# Administrative Approval Action

SR-114-18 / 2413 Blue Ridge Road – North State Bank  
Transaction# 578800 AA#3955

# Design Adjustment Staff Response

## Staff Report

**SITE PLAN**

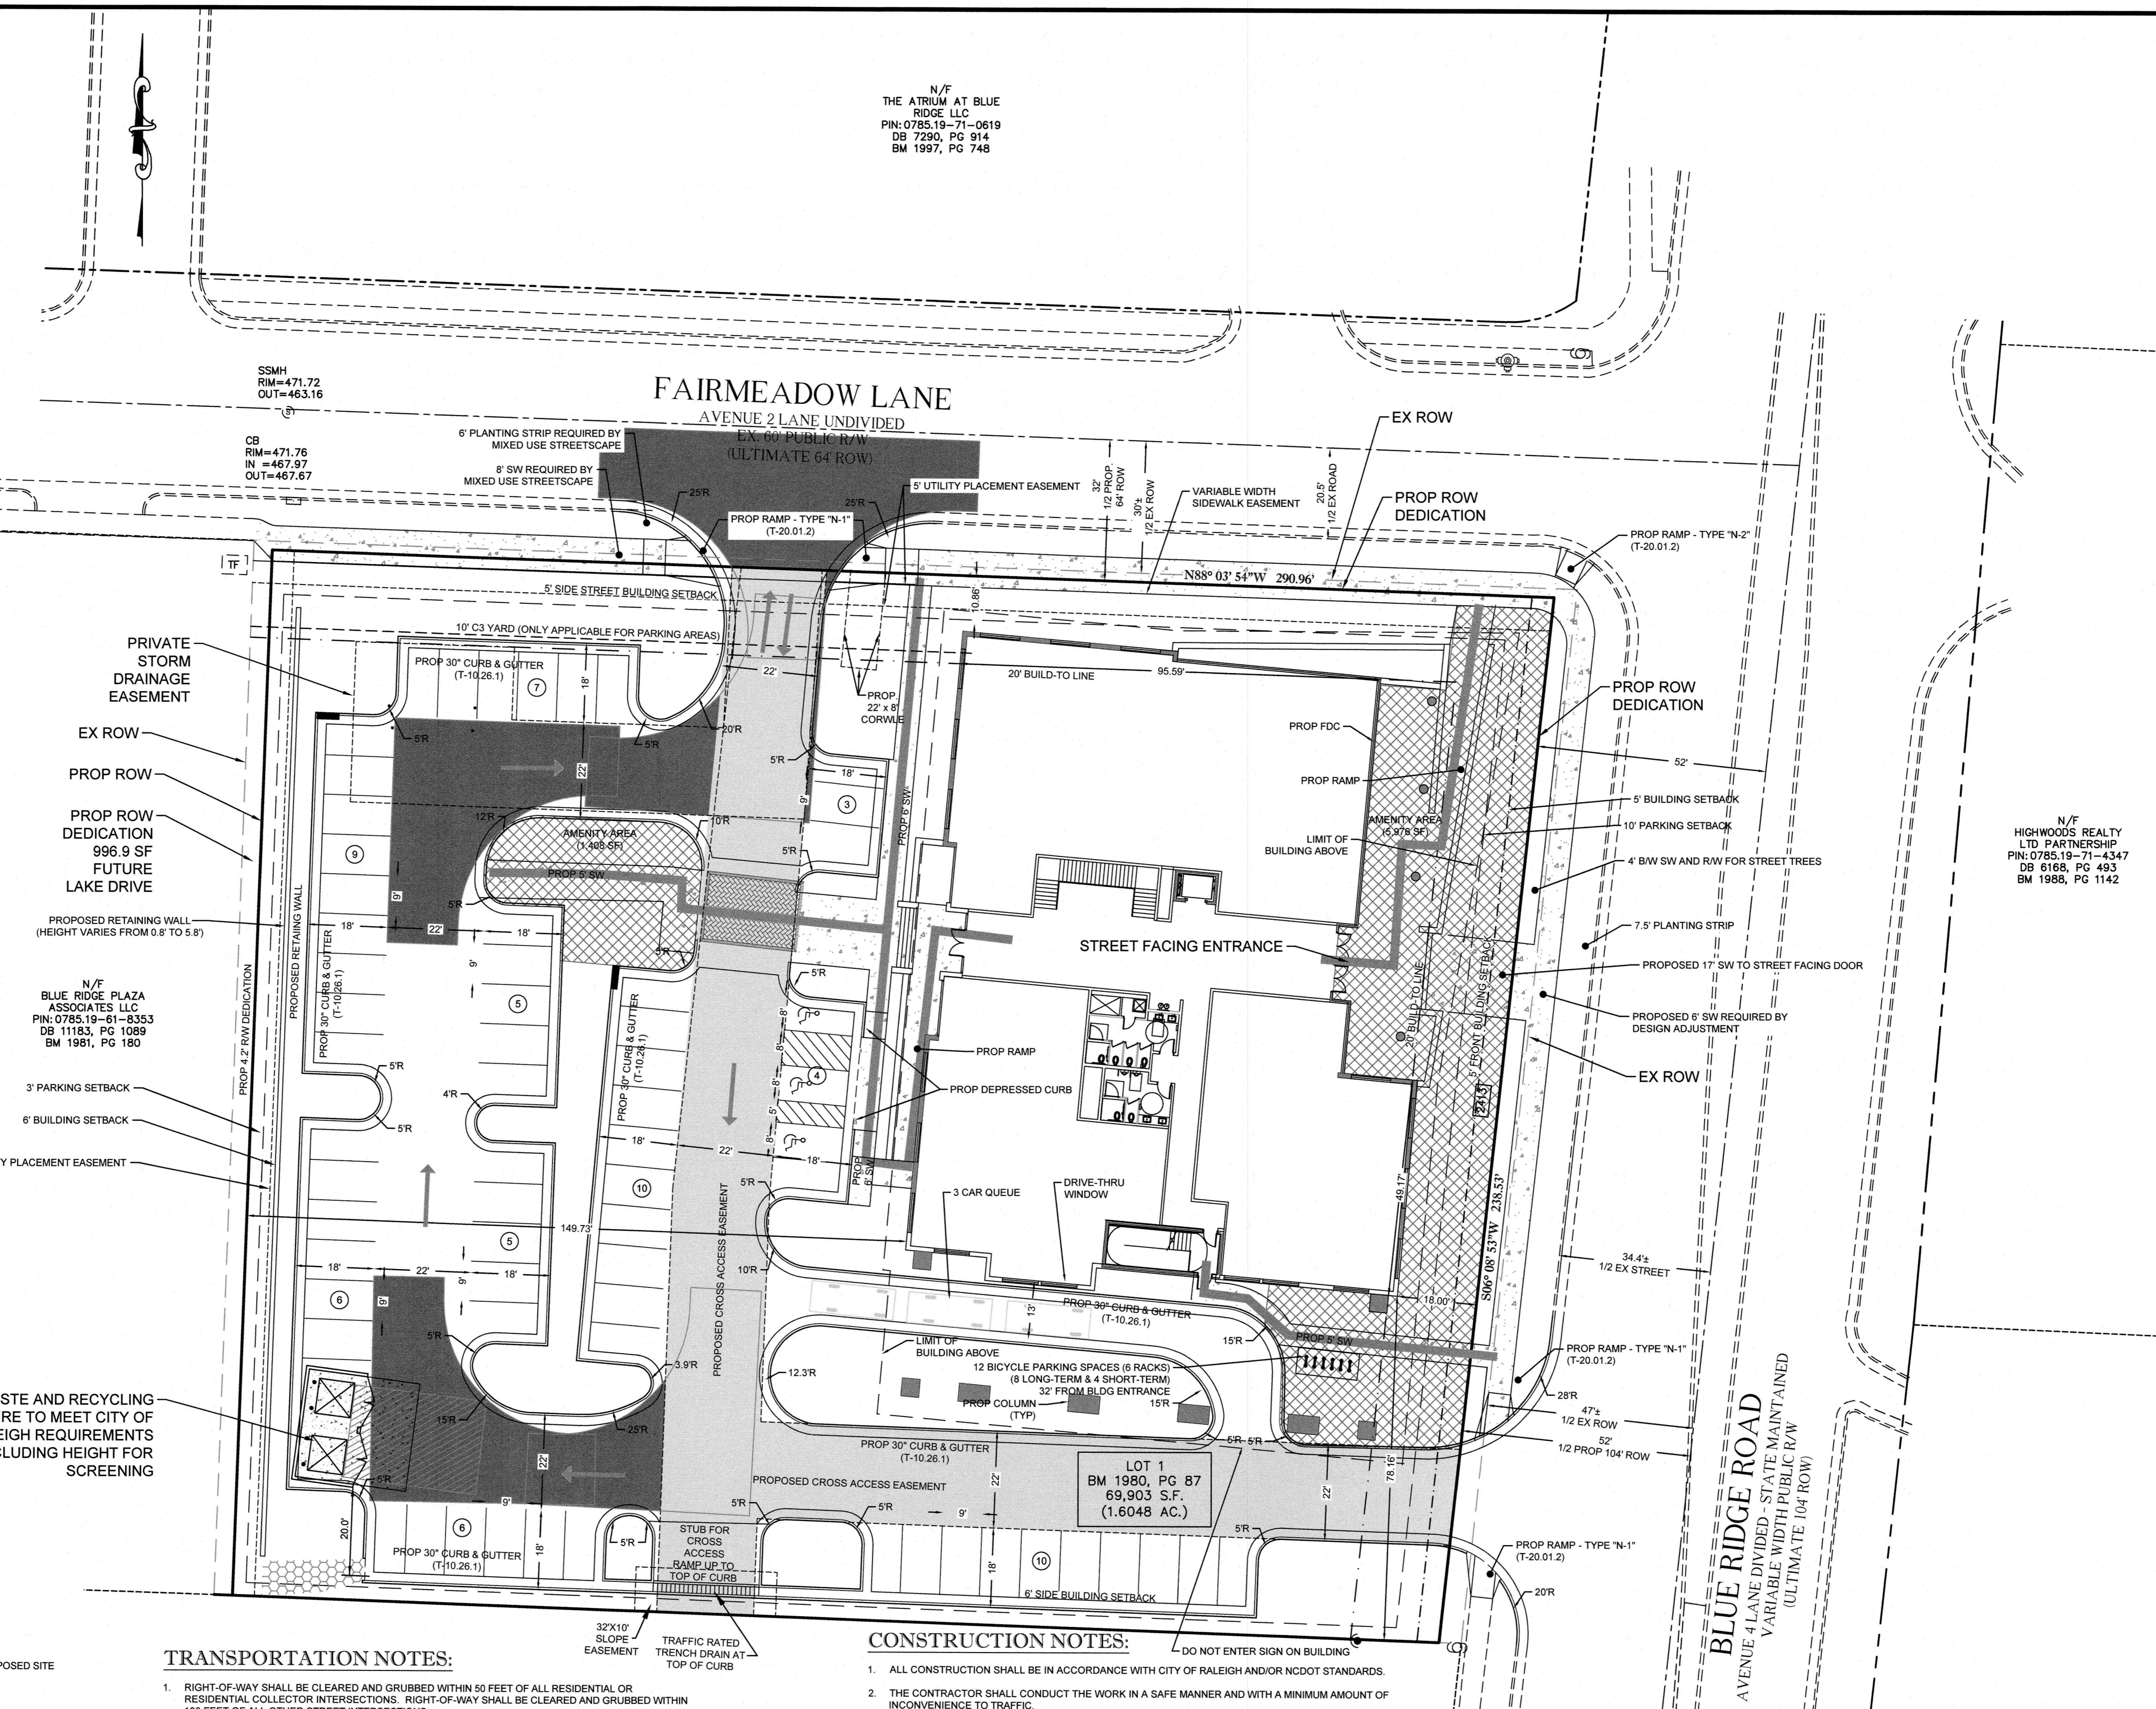
The developer has proposed a planting strip of 7.5' between the existing back of curb and sidewalk face. The City has identified a need for a bike lane on Blue Ridge Road that would approach 7.5' in length consistent with the Blue Ridge Corridor Plan. A 6' sidewalk is proposed thereby leaving a 4' planting strip for street trees within the right of way. NCDOT has indicated that street trees cannot be placed in the planting strip behind the back of curb. The 5' utility placement easement is proposed to be removed and is also supported by staff.

The proposed streetscape sets the frontage for both pedestrian and bike mobility while keeping street trees in the public right of way. Without the proposed design adjustment, the sidewalk would be impacted with construction of a new bike lane resulting in additional construction of the relocated sidewalk.

**Future planned bicycle facilities along Blue Ridge Road are in conflict with the UDO streetscape requirement and therefore the proposal is requesting an alternate section to allow room for future bicycle facilities as well as alternate placement of street trees. Blue Ridge Road is a NCDOT maintained facility and street trees are not allowed in the plant strip between the sidewalk and curb within NCDOT facilities. The proposal is to provide a 7.5' grass strip which allows for future bicycle facilities, a 6' sidewalk, and 4' plant strip for street trees.**

SHEET NUMBER  
**A201**

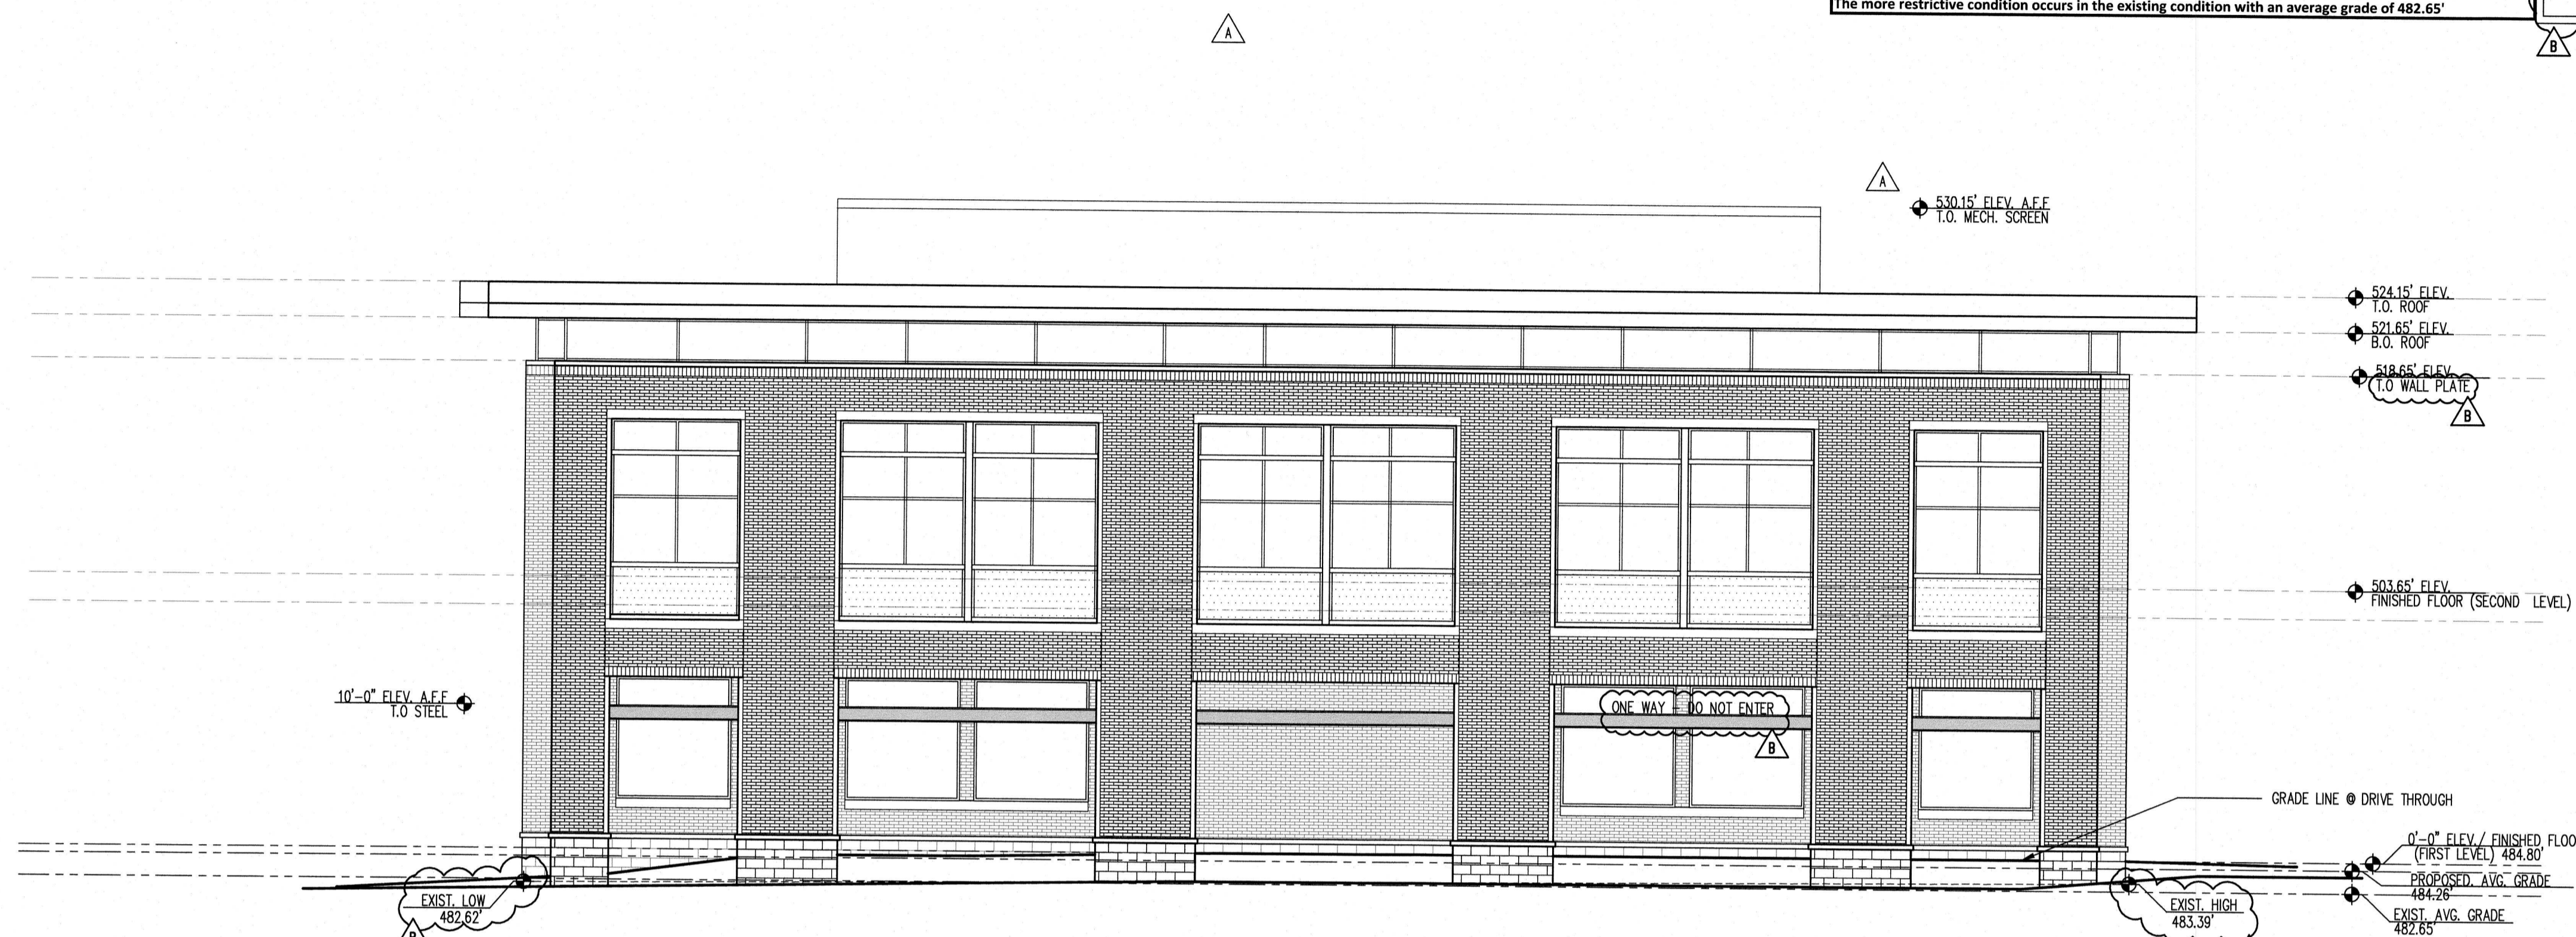
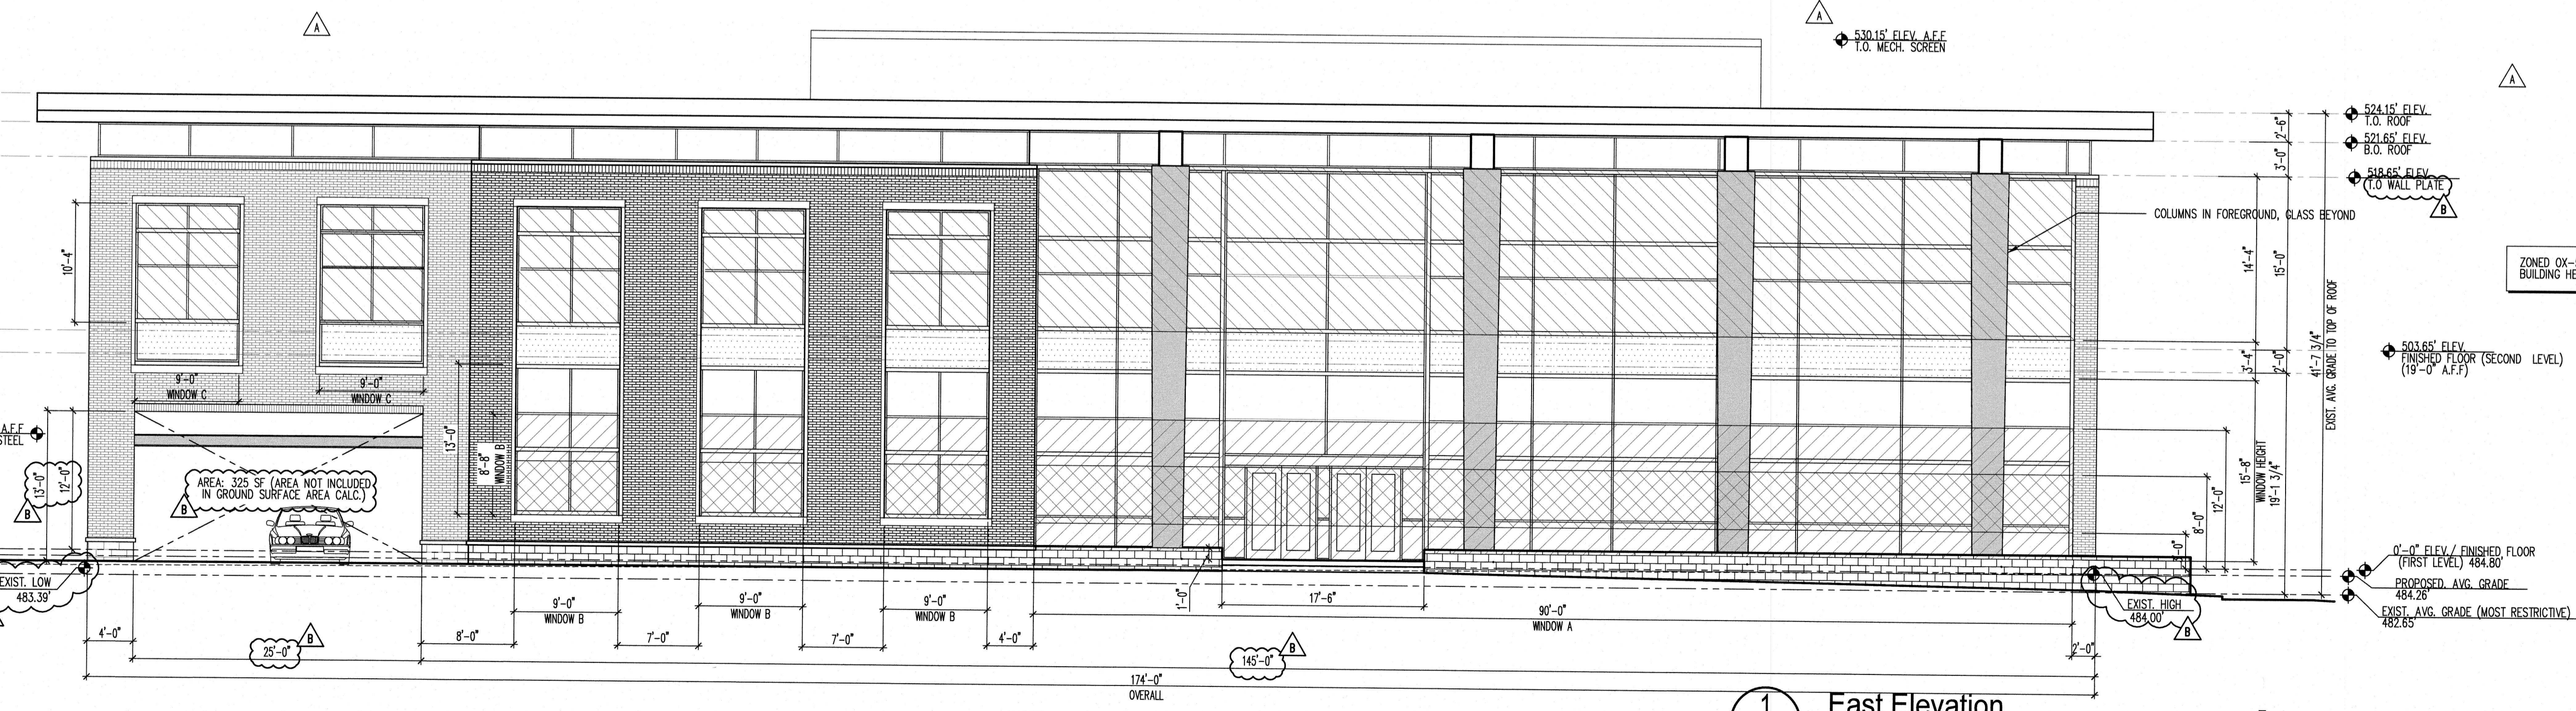
NOTE: ADDED DIMENSIONS DELINEATING WINDOW SIZES
